**LODI UNIFIED SCHOOL DISTRICT**

**2020 Paving Project(s) – Phase II**

**ADDENDUM NO. 1**

March 06, 2020

**C6.3**

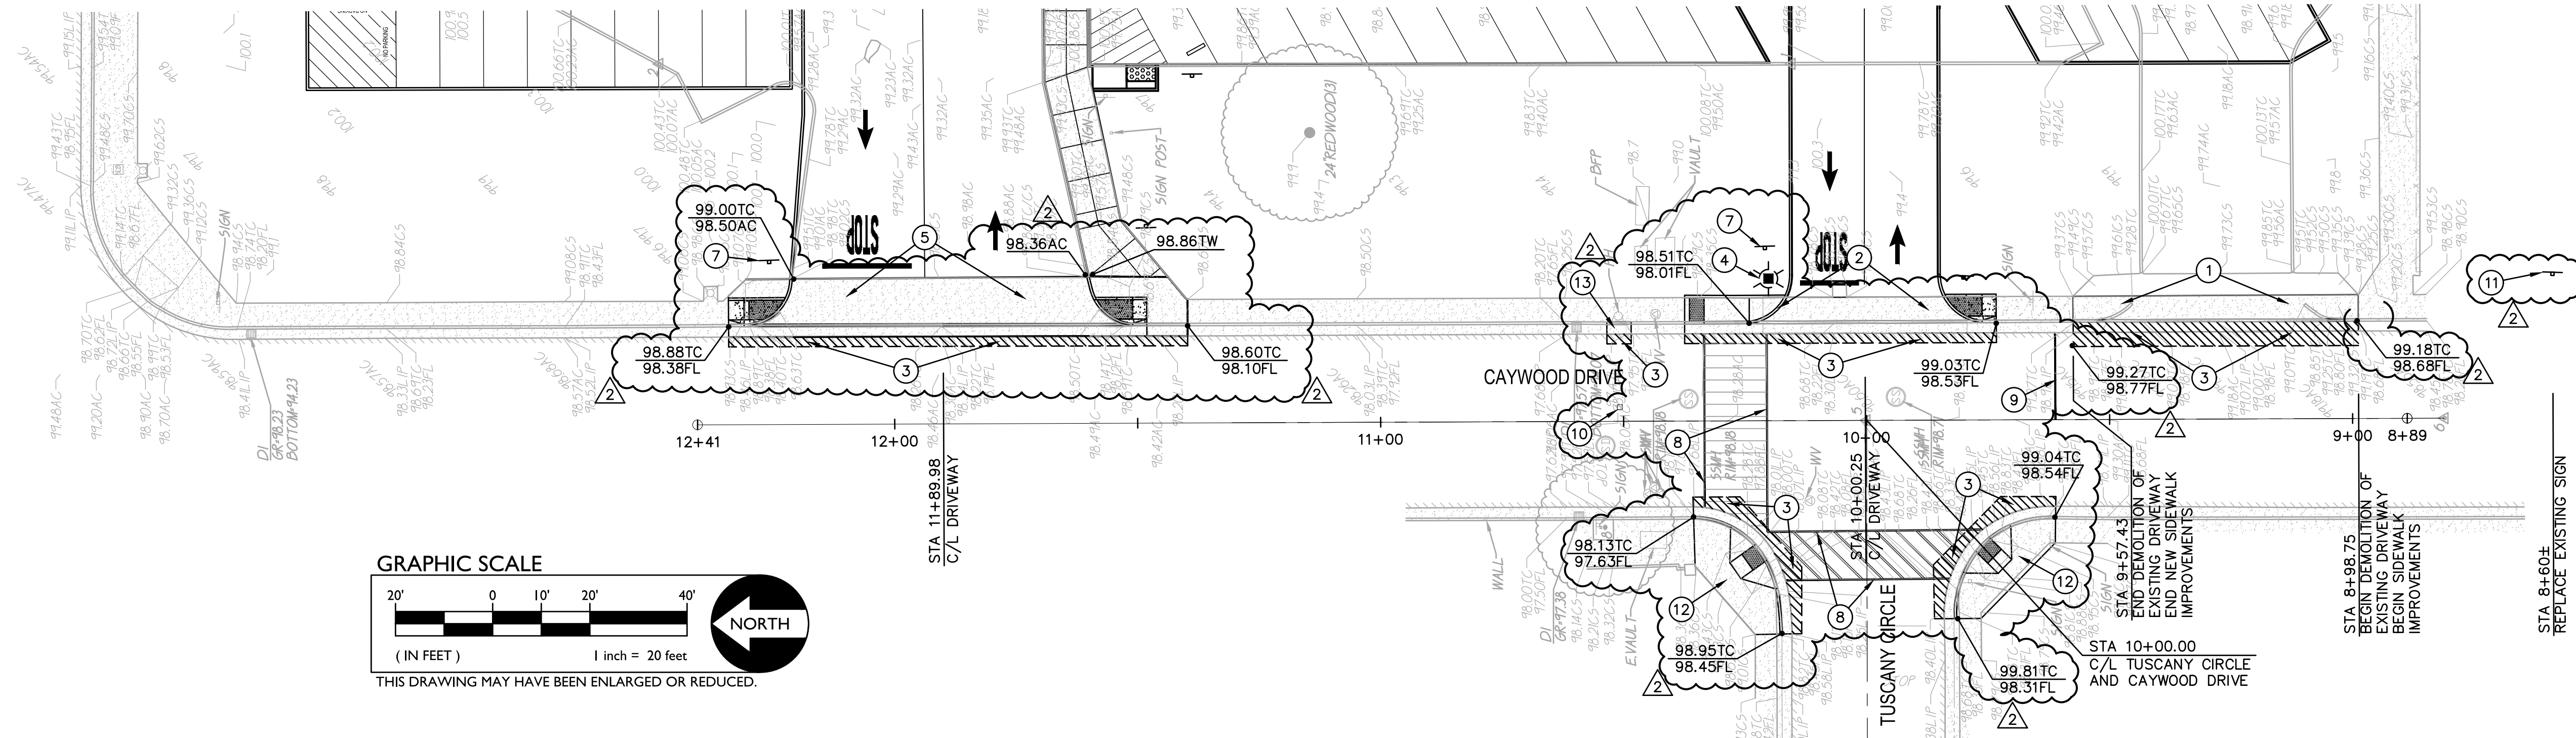
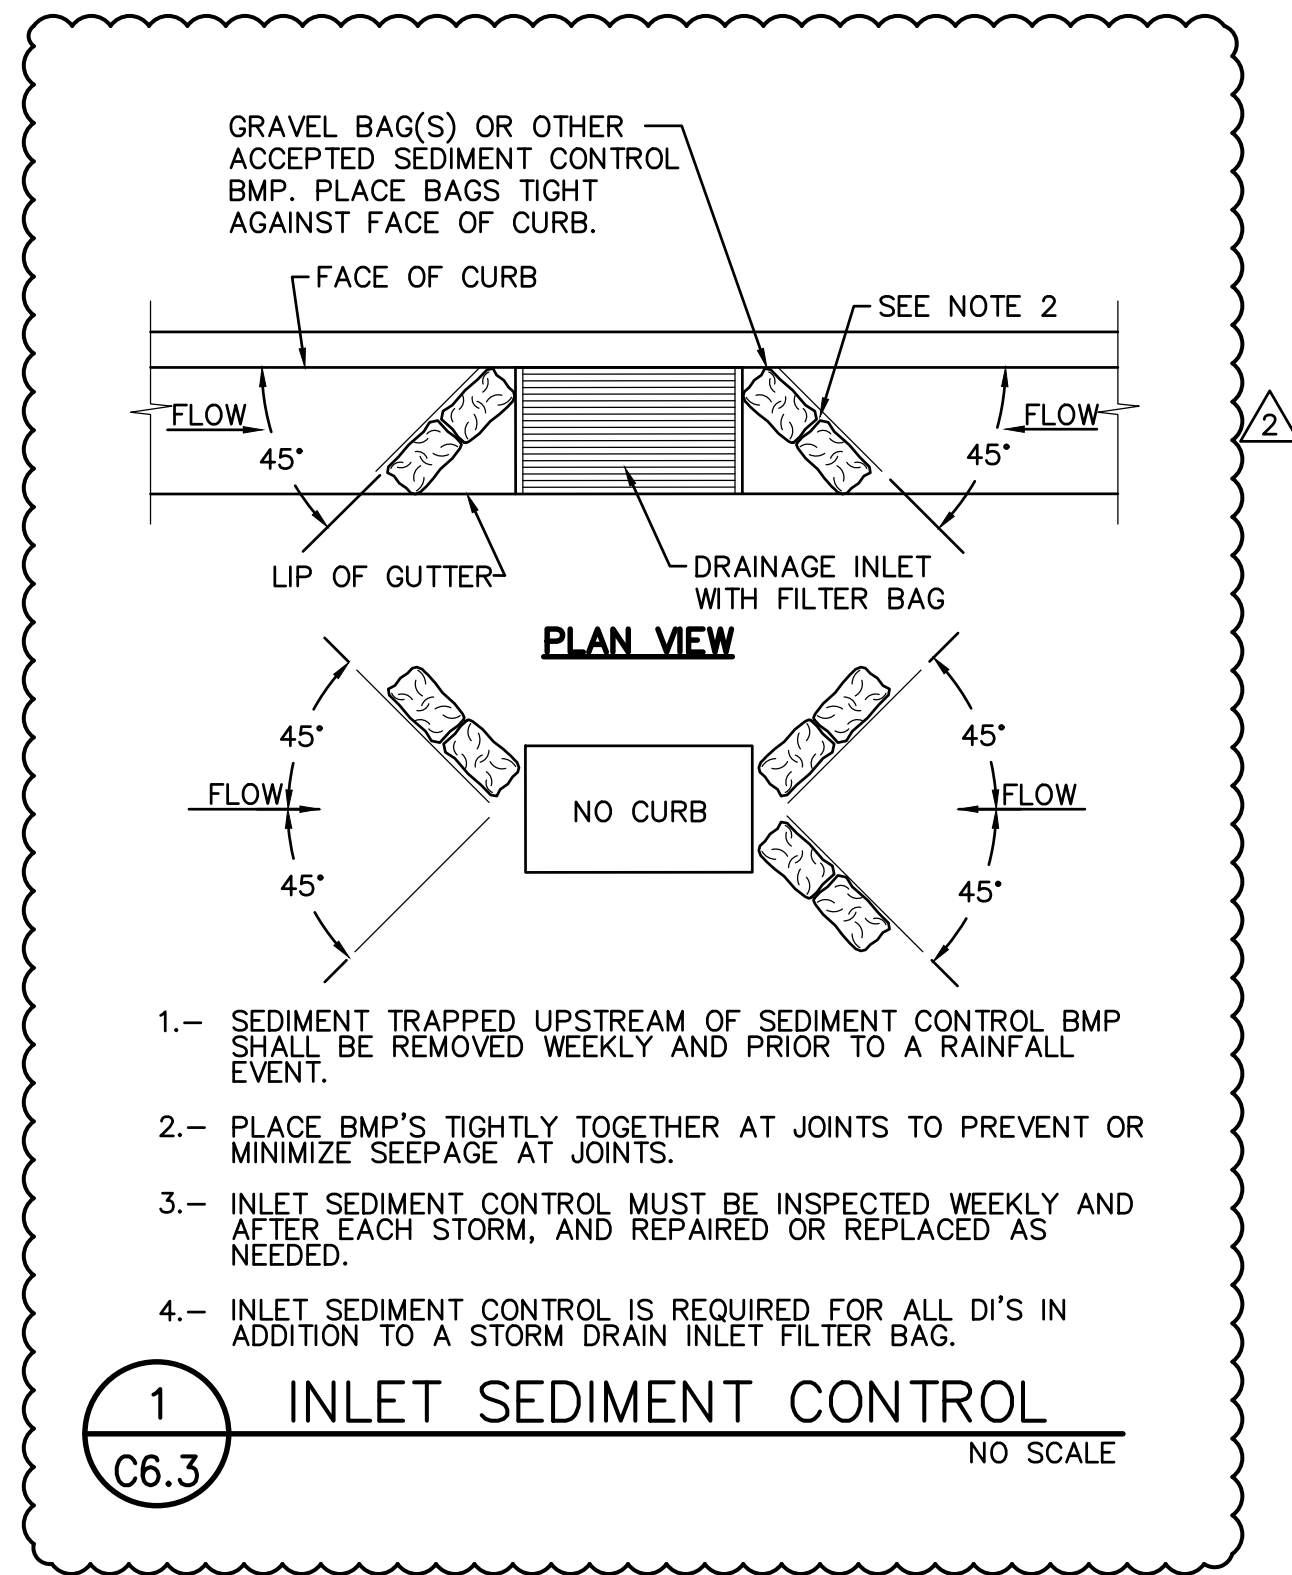
- 1.5 Westwood Elementary School - Project #0951-8251 – DSA #02-118115. Refer to Drawing Sheet C5.1 Frontage Improvements. **Delete** sheet C5.1. (Reference new added sheets C6.1, C6.2 and C6.3).

- 1.8 Westwood Elementary School - Project #0951-8251 – DSA #02-118115. Refer to new Drawing Sheet C6.3 Frontage Improvements, dated 03/04/2020. **Add** to drawing set.
